## **SOLICITATION AMENDMENT MODIFICATION DE L'INVITATION**

<b>Title - Sujet</b> Fence Detection System	
<b>Solicitation No. - N° de l'invitation</b> 21120-148250/A	<b>Amendment No. - N° modif.</b> 002
<b>Client Reference No. - N° de référence du client</b> 21120-14-1948250	<b>Date</b> 2015-03-11
<b>GETS Reference No. - N° de référence de SEAG</b> PW-\$\$HN-329-66700	
<b>File No. - N° de dossier</b> hn329.21120-148250	<b>CCC No./N° CCC - FMS No./N° VME</b>
<b>Solicitation Closes - L'invitation prend fin</b> <b>at - à 02:00 PM</b> <b>on - le 2015-04-13</b>	<b>Time Zone</b> <b>Fuseau horaire</b> Eastern Daylight Saving Time EDT
<b>F.O.B. - F.A.B.</b> <b>Plant-Usine:</b> <input type="checkbox"/> <b>Destination:</b> <input checked="" type="checkbox"/> <b>Other-Autre:</b> <input type="checkbox"/>	
<b>Address Enquiries to: - Adresser toutes questions à:</b> Dumaresq, Steve	<b>Buyer Id - Id de l'acheteur</b> hn329
<b>Telephone No. - N° de téléphone</b> (819) 956-3487 ( )	<b>FAX No. - N° de FAX</b> (819) 953-4944

**This Amendment 002 is raised to answer the following questions:**

DWG/PART DESCRIPTION  
**INSTALLATION DIAGRAM,  
ARCHAMBAULT, FDS**

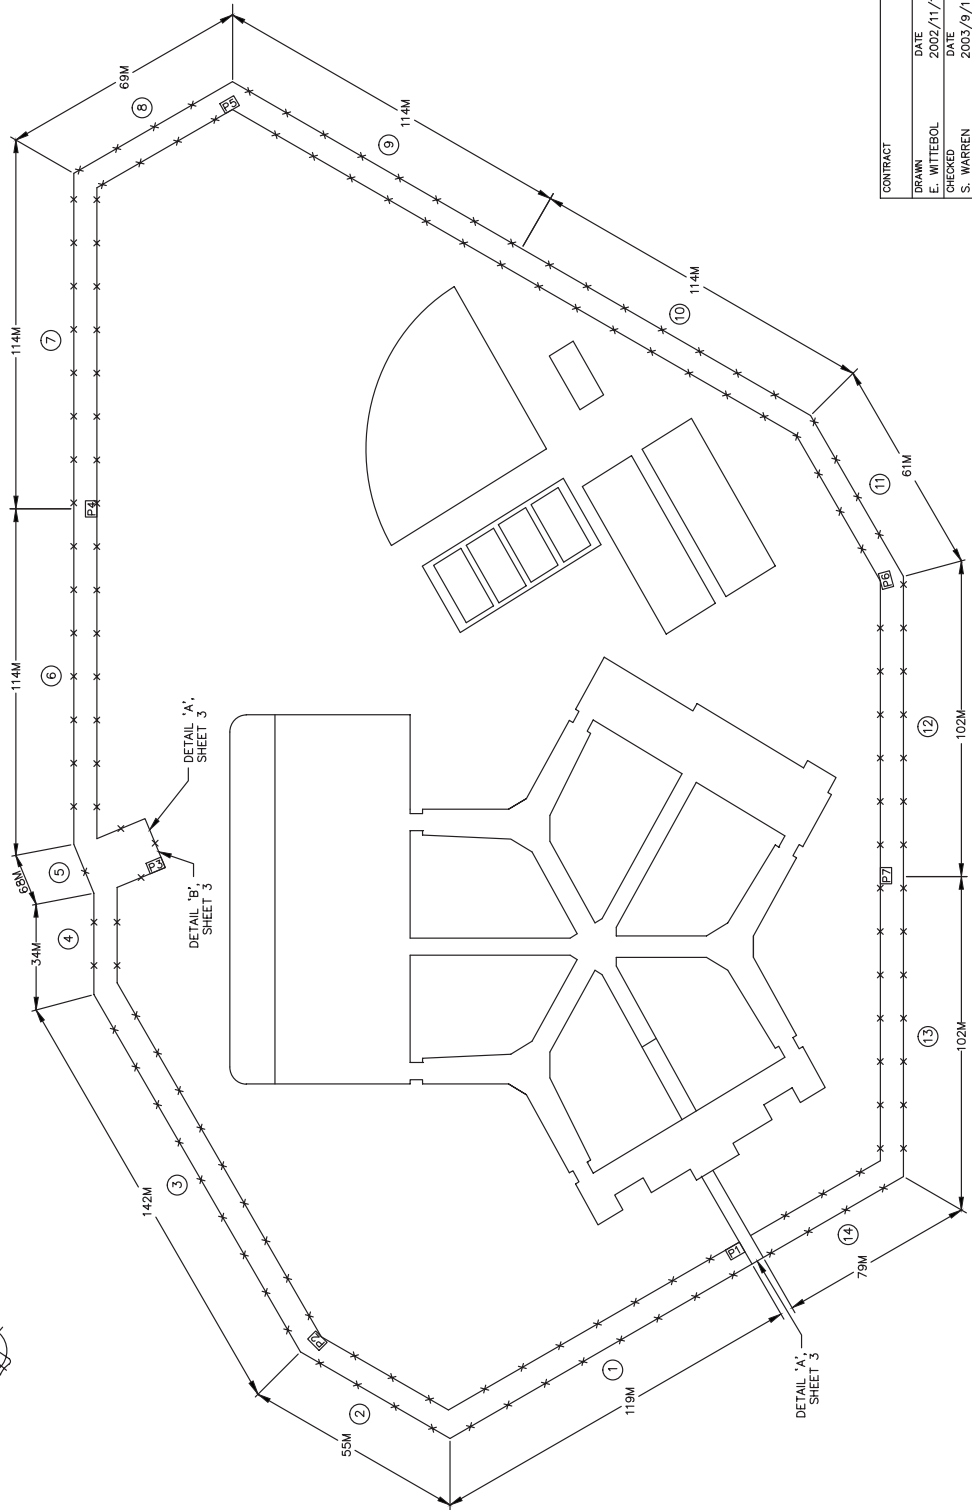
2) Can we confirm the perimeter length?  
See attached drawing.
